STATE OF NORTH CAROLINA
DEPARTMENT OF TRANSPORTATION

Subject: **Corrections to the Application for Section 404 Nationwide Permits 13, 23, 33 and Section 401 Water Quality Certification** for the proposed replacement of Bridge No. 127 over Pinch Gut Creek on SR 1880 (St. James Church Road) in Catawba County, Federal Aid Project No. BRZ-1880(1); Division 12; TIP No. B-4062, \$240.00 debit WBS 33426.1.1

Reference: NCDOT permit application dated April 15, 2010

Revised Permit Drawing
5/27/10 Sheet 6 of 7

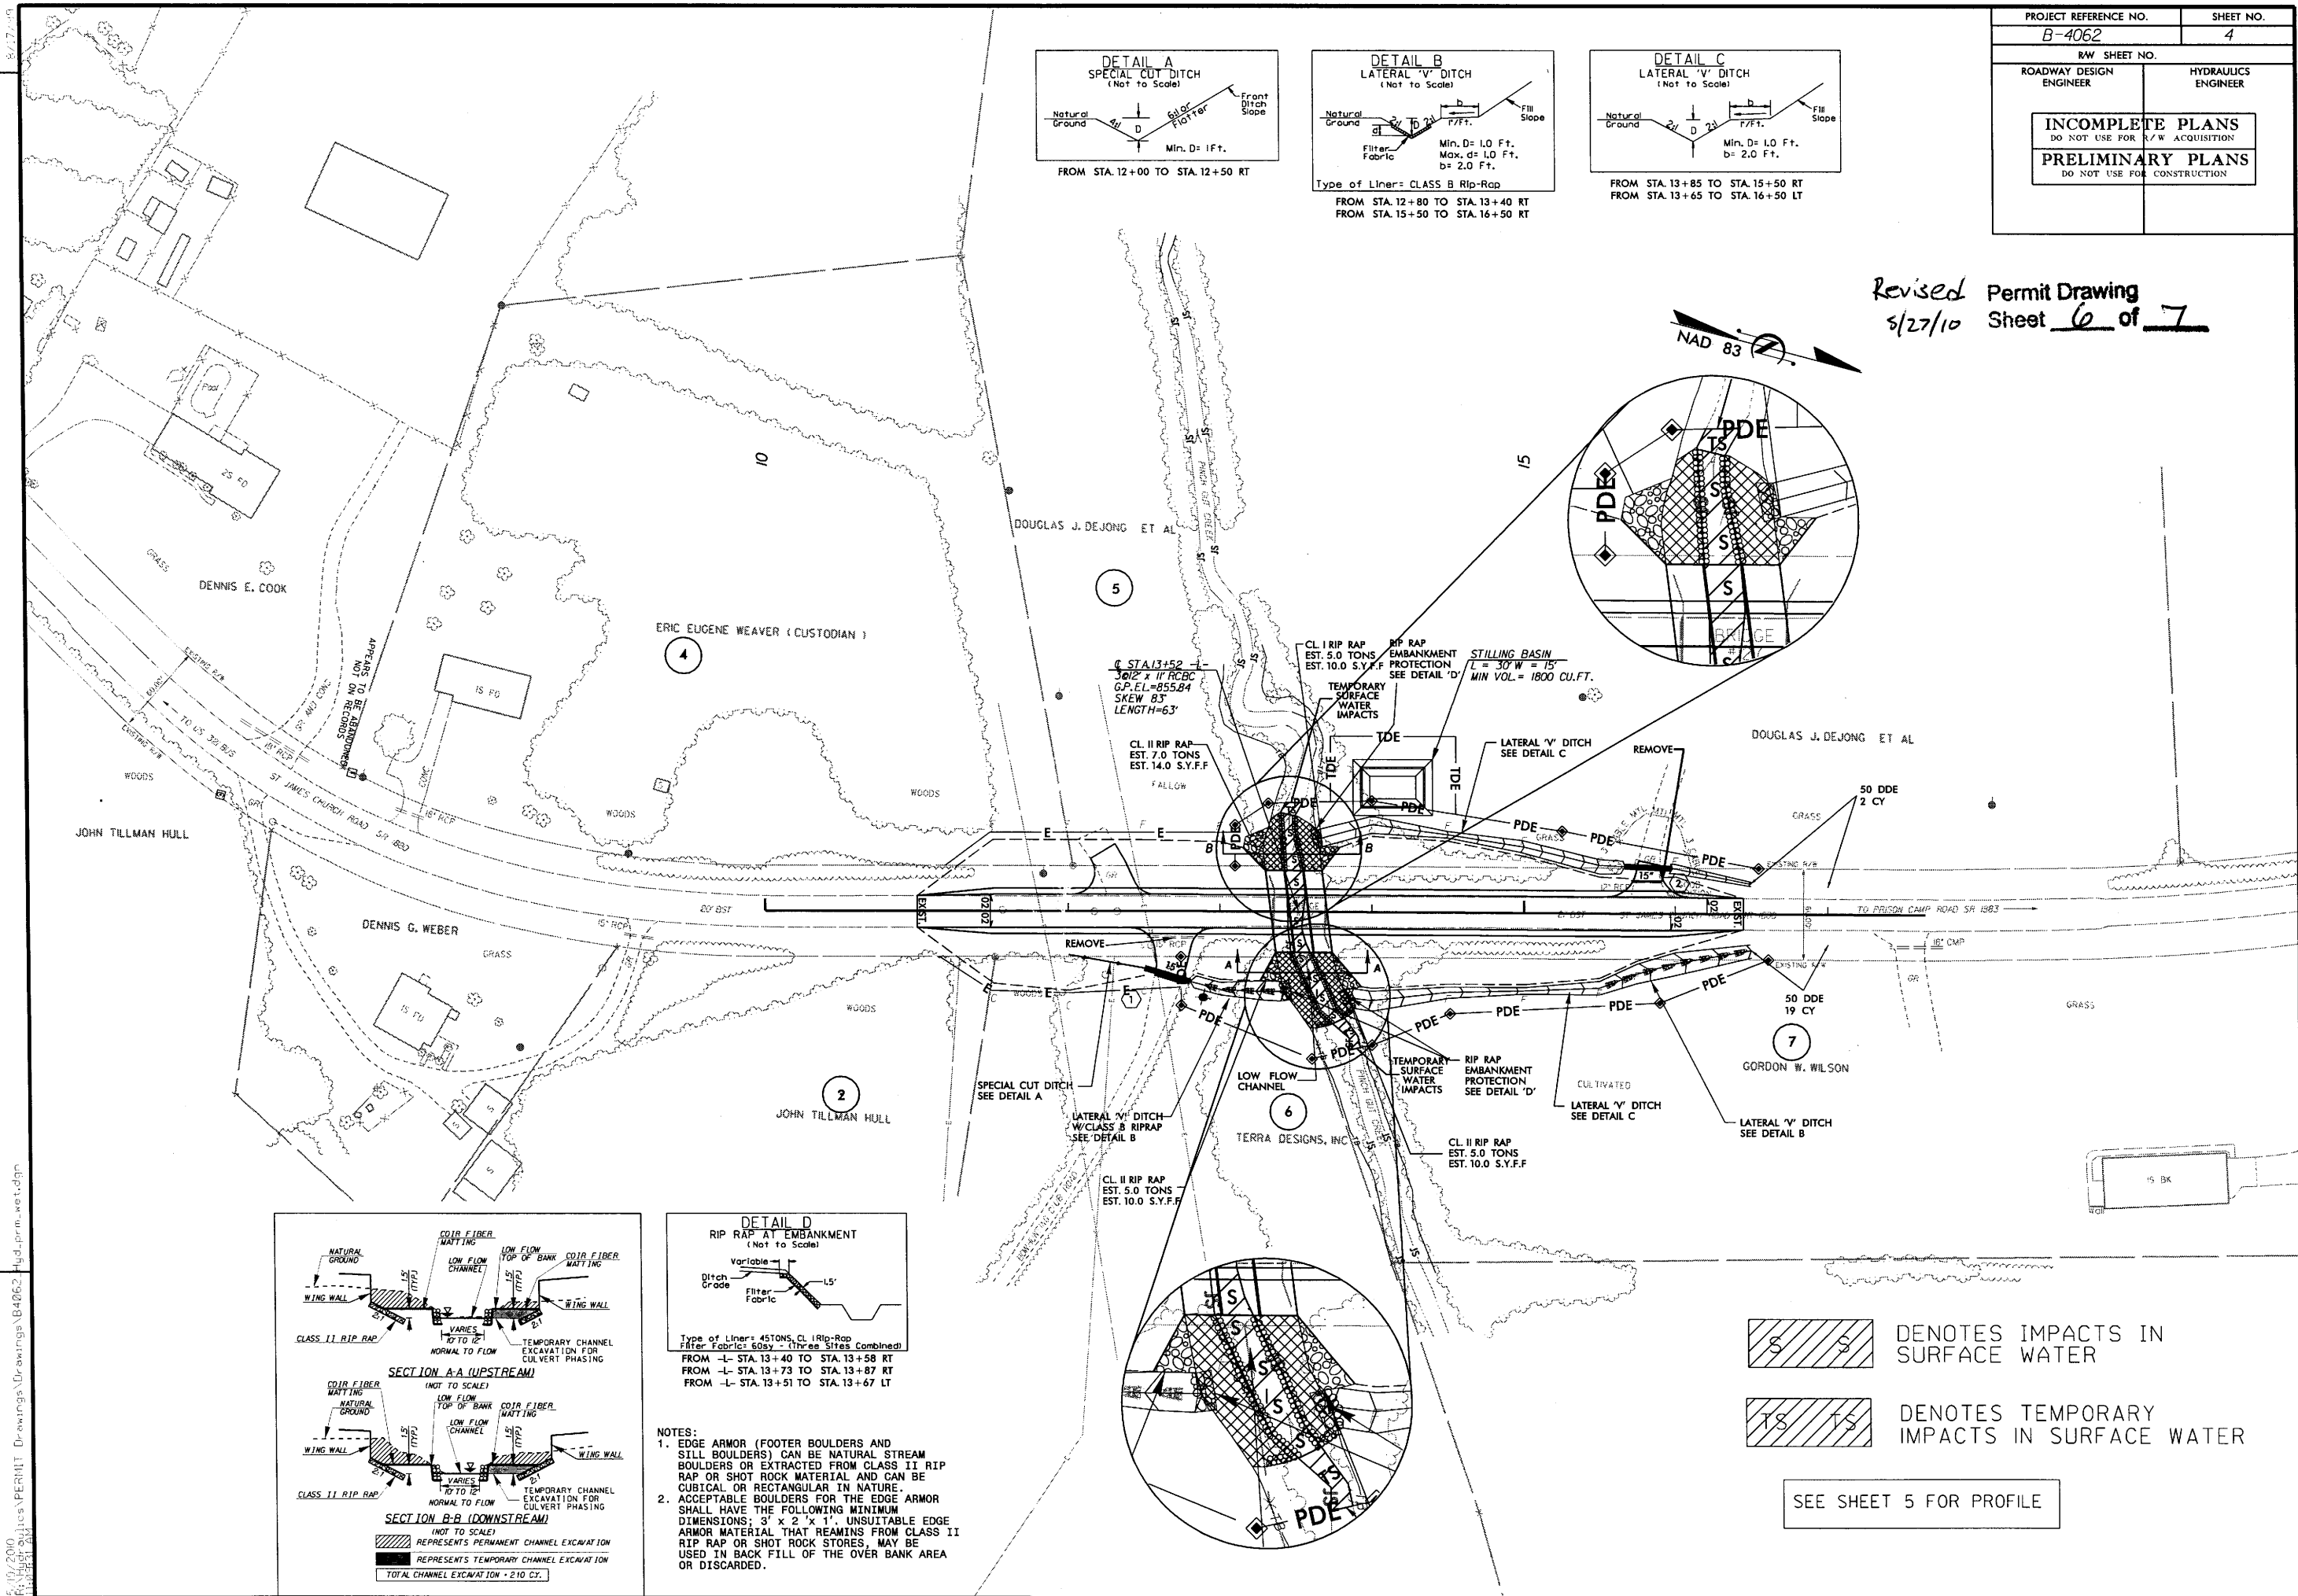
- Detail "D" was added to the roadway drawings.
- The size of riprap used in Detail "D" has been changed to Class I on the permit drawings.
- Detail of culvert (upstream and downstream)
 - Size of riprap has been changed to Class II on roadway drawings to match permit drawings.
 - Use of coir fiber matting at inlet and outlet of culvert has been added to roadway drawings to match what is shown on permit drawings.
